APPROVAL of a PBP Conceptual Plan for "Cornerstone Family Church" located in the vicinity of 4375 SW 63rd Street to allow development of 16.3 acres for office/business park use and a four (4) acre outlot, subject to the following:
(ZON2007-00175)

APPROVAL of a preliminary subdivision plat "Cornerstone Family Church Plat 1", subject to the following:

STAFF RECOMMENDATION AND BASIS FOR APPROVAL

STAFF REPORT

PRELIMINARY PLAT CORNERSTONE FAMILY CHURCH

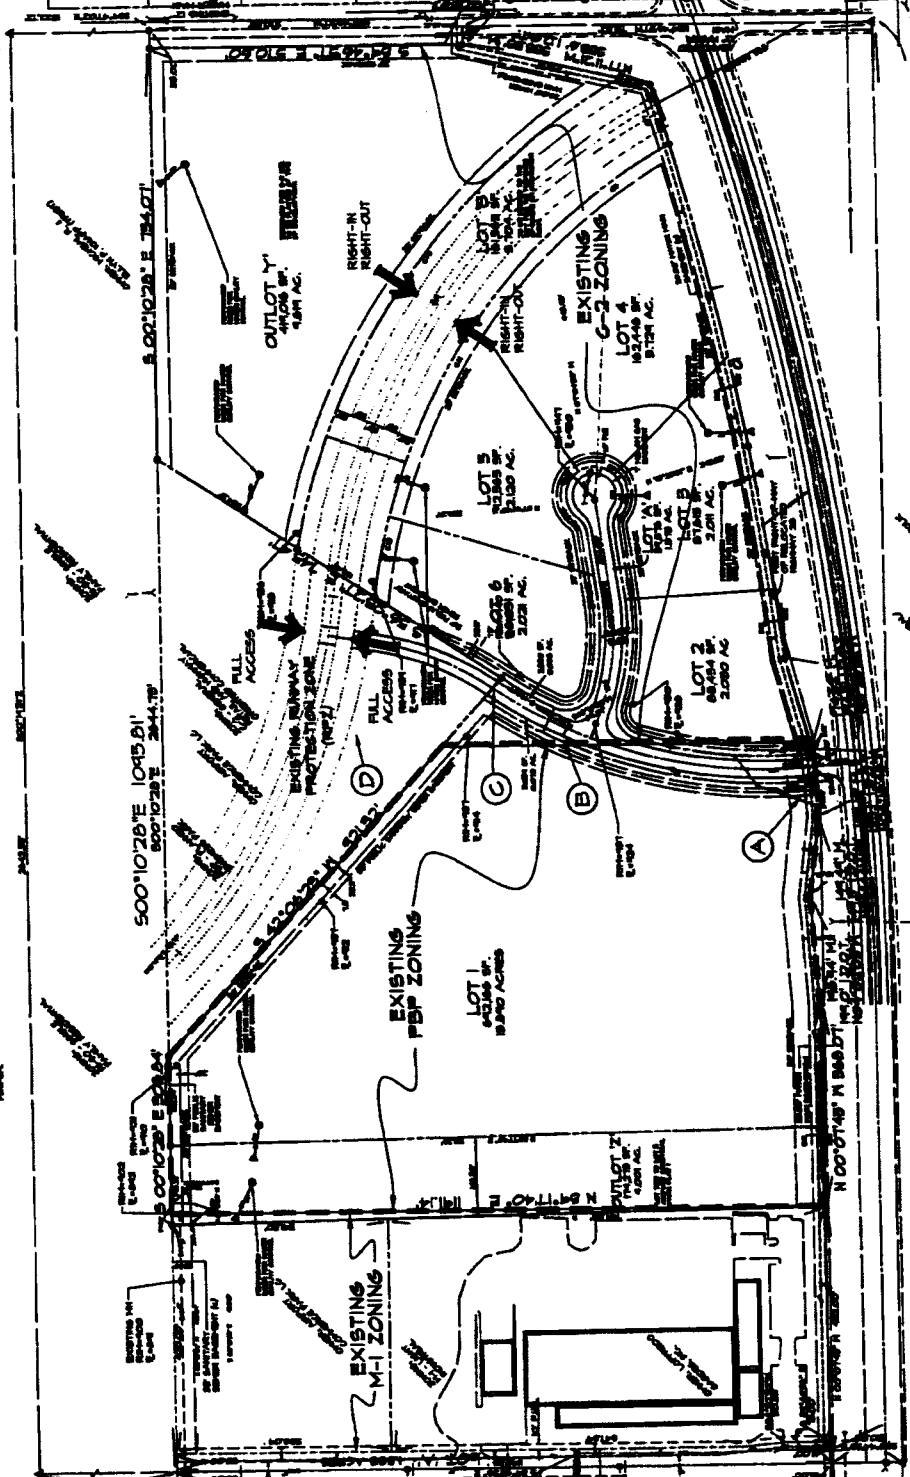
1. Compliance with all Preliminary Plat requirements of the Permit and Development Center.
2. Provision of covenants that Lots 1 through 6 are responsible for construction of the remaining portion of Stanton Avenue that will extend to the SW Connector in the future.

Part B) Staff recommends approval of the Cornerstone Family Church Plat 1 subject to the following:

1. Compliance with all Preliminary Plat requirements of the Permit and Development Center.
2. Provision of covenants on Lots 1 through 6 that waive the owners' right to protest a future special assessment when the City constructs the remaining portion of the north/south street.
